**North America's
Full Service
Jabiru Center**

SERVICE BULLETIN	
Service Bulletin #	JSA-005
Superseded Bulletin #	N/A
Issue Date	10/07/2010
Effective Date	10/07/2010
Limitations for Completion	Contingent Upon Inspection
Make & Model Affected	J250-SP – All through s/n 585
	J230-SP – All through s/n 679
	J170-SP – All through s/n 186
Page 1 of 4

Service Bulletin JSA-005 has been issued to correct a bolt-clearance problem in the brake/wheel pant bracket assembly that will cause abnormal brake wear and loss of brake effectiveness over time.

Figure 1: Rear view of left caliper and bracket. With brake applied, caliper bolt contacts bracket. (Note slight bow in bracket.)

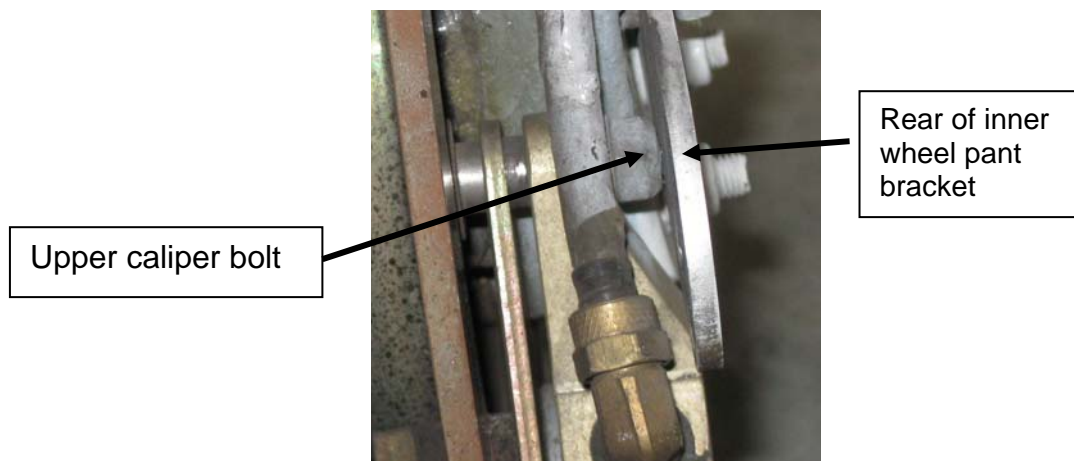
During annual inspection of an aircraft with worn brake pads, the mechanic noticed contact between the upper brake caliper bolt and the inner wheel pant bracket (see Figure 1) when brakes were applied. The interference prevented the outer brake pad from contacting the brake disc, which caused abnormal wear of the inner brake pad and reduction of brake effectiveness. The problem was corrected by drilling a relief hole in the inner wheel pant bracket to allow the bolt to pass through the bracket with no contact.

- c. Materials and Parts Required
 - i. 4 x AN365-428 Locking nuts (new)
- d. Remove main wheel pants as per applicable aircraft service manual.
- e. Apply and lock parking brake. Examine the upper caliper bolt clearance to the wheel pant bracket. If the bolt hits the bracket (see Figure 1) or clearance is less than 1/16", the clearance hole must be drilled before the next flight. If the clearance with brake applied is 1/16" or more on both brake assemblies, the relief hole may be drilled at the next 100-hour or annual inspection.

- f. If clearance is less than 1/16", remove inner wheel pant bracket. If the bolt has contacted the bracket, there may be a mark which can be used to locate the clearance hole. If no mark is present, drill a pilot hole approx. 1 1/8" from the center of the aft bolt hole and 3/8" up from the bottom edge of the bracket (see Figure 2). Enlarge the hole to at least 9/16" using the Uni-Bit. If the edge of the clearance hole is less than 1/8" from the lower edge of the bracket, it is acceptable to remove the material and create a rounded notch, rather than a hole. Deburr and polish edges of hole/notch.

- g. Reinstall inner wheel pant bracket using new AN365-428 nyloc nuts and standard AN torque specifications. Apply full brake and inspect to ensure there is no further contact between bolt and bracket.
